Overview

Xilinx is changing the humidity indicator card (HIC) used in the dry packing process.

Figure 1: Before

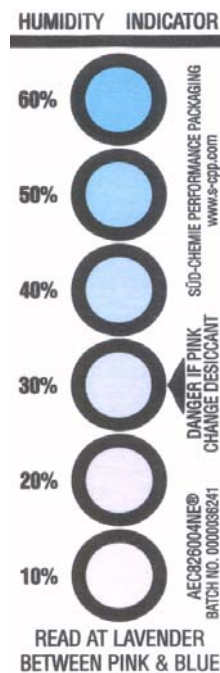
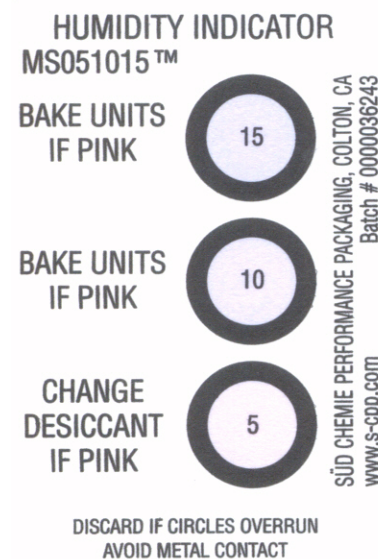
To comply with industry standard dry packing requirements, JEDEC standard J-STD-033, Xilinx is changing from a 6 dot HIC to a 3 dot HIC. This change is occurring in Q4CY2004.
